<b>Notice of Allowability</b>	<b>Application No.</b>	<b>Applicant(s)</b>	
	10/813,378	VOGMAN, VIKTOR D.	
	<b>Examiner</b>	<b>Art Unit</b>	
	Jeffrey L. Sterrett	2838

### EXAMINER'S AMENDMENT

FIG. 5

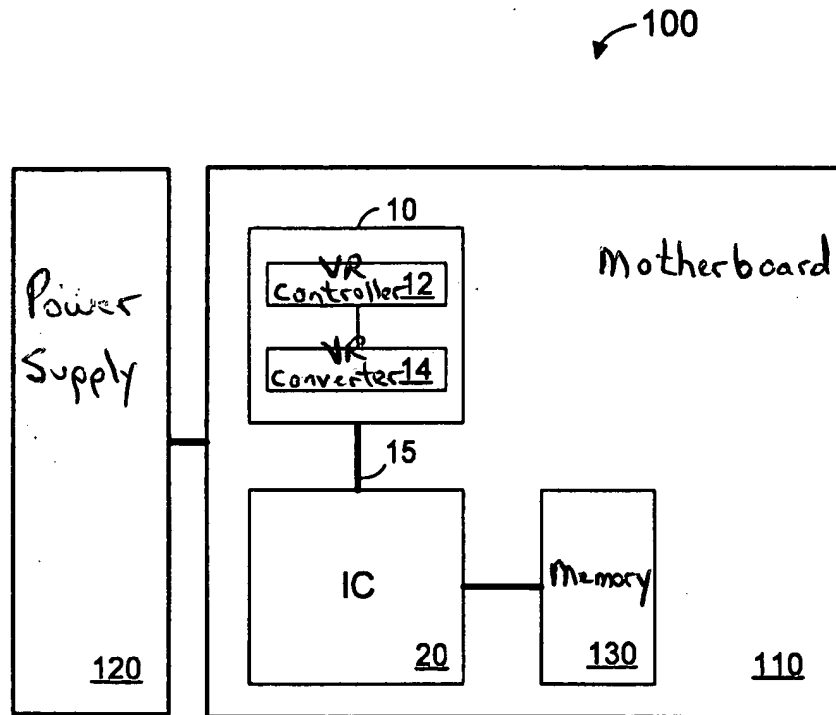
Note attached copies of the drawings corrected in red.
